NUMBER: 23-007-17 REV. C

Front and Rear Crossmember Corrosion (X69 Warranty Extension)

OVERVIEW:

2008 - 2012	(PM)	Dodge Caliber
2008 - 2012	(MK)	Jeep Compass/Patriot

Fig. 1
Crossmember Needing Replacement

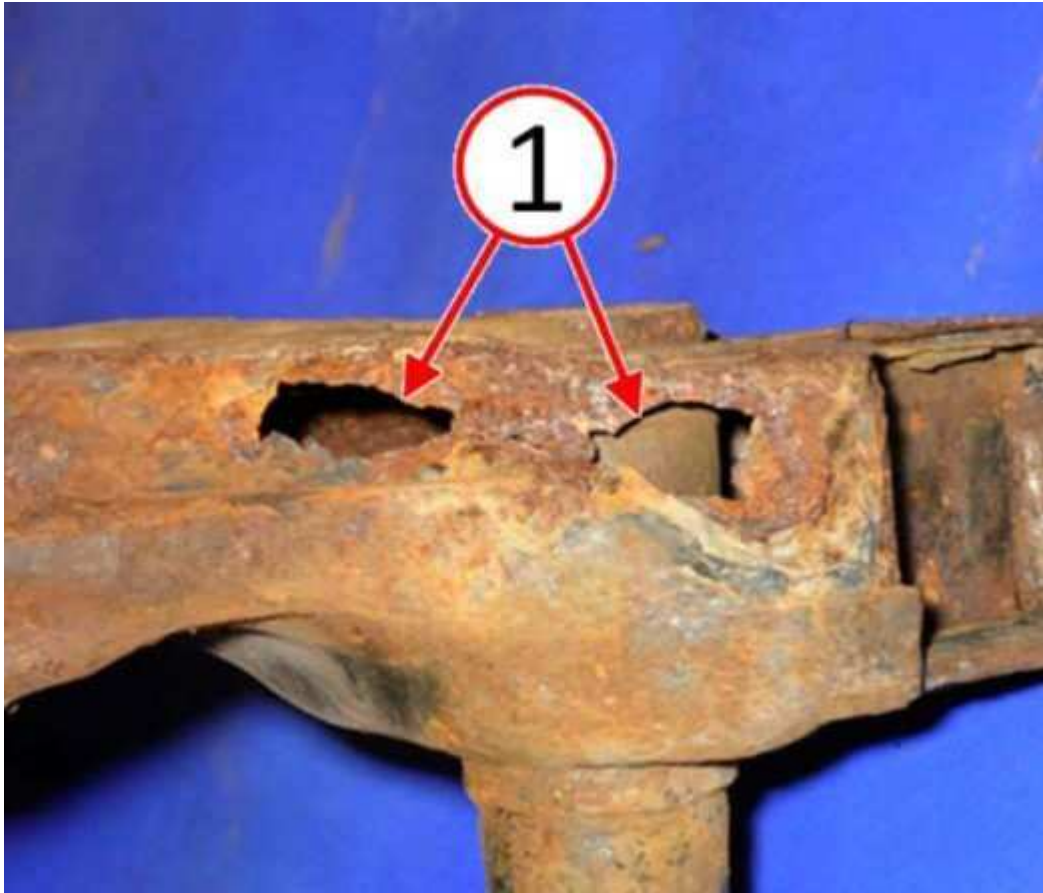
2. **NOTE: Any perforation/rust through of either suspension crossmember, regardless of hole size or area affected, will require crossmember replacement.**

Inspect the front and rear crossmembers for perforation/rust through (Fig. 1) . Was perforation/rust through found on either the front or rear crossmember(s)?

- a. YES >>> Continue to the Repair Procedure [Step 1](#).
- b. NO >>> Return the vehicle to the customer and advise the customer to return for yearly inspections until the vehicle reaches 10 years of age.
